# SERVICE MEMO

Dispenser(s): *Kometa*  
Title: Drip tray presents sensor

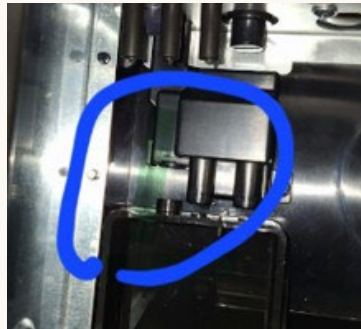
The presence of the Kometa drip tray is recognised by a sensor, which is activated by a magnet on the drip tray.

In the first production machines Evoca found out the drip tray was recognized even if it was not in the proper position with leakage under machine as result. So, Evoca moved the sensor further away from the drip tray to be sure the end user/operator would position the drip tray in the right position.
